## **TECHNICAL MEMORANDUM**

# RESPONSE TO THE JOINT AGENCY REVIEW TEAM LETTER - AIR QUALITY IMPACT ASSESSMENT - PORT COLBORNE QUARRIES INC., PIT 3 EXTENSION

# JART Response

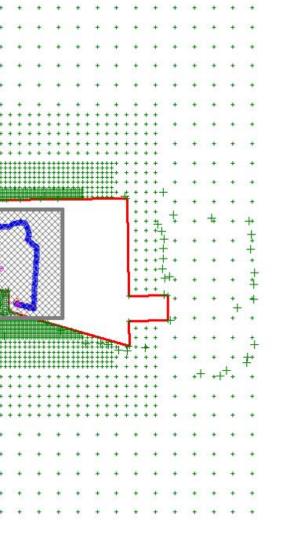
Comment ID	Comment	Respons
3.c.i	In section 4.5.2.2 the description of how grid-based receptors were selected for dispersion modelling seems to suggest square grid areas (200m x 200m, 300 m x 300 m etc.); however, the example receptors grid layout shown in Figure 5 is clearly not square. This section should be revised to clarify the starting boundary for the grid-based receptors, and how the receptor grids increase in spacing with distance from the starting boundary (such as 20 m grid spacing for receptors up to a distance of 200 m from the starting boundary).	The receptors used in the assessment were generated in accor Regulation 419/05 and Section 7.1 of the February 2017 Air Dis receptors up to 2 km out from the source box, using the nested Environmental AERMOD View program. A source bounding bo around the emission sources in each scenario and receptors we The shape of the receptor grid depends on the shape of the bor below has 20 m spaced receptors starting at the bounding box bounding box (area described as "(a)" in the ADMGO). Further m of the area described as "(a)".

As the bounding box is rectangular, so is the shape of the recept
		* * * * * * * * * * * * * * * * * * *
		* * * * * * * * * * * * * * * * * * *
		* * * * * * * * * * * * * * * * * * * *

cordance with the requirements of Section 14 of Ontario Dispersion Modelling Guideline for Ontario (ADMGO), for ed grid receptor generating tool in the Lakes box (coloured grey in the image below) was drawn were generated in grids with different spacing intervals.

bounding box. For example, the nested grid in the image x and extending to 200 m away from each side of the er, the 100 m spaced receptors are in an area within 800

#### eptor grid.
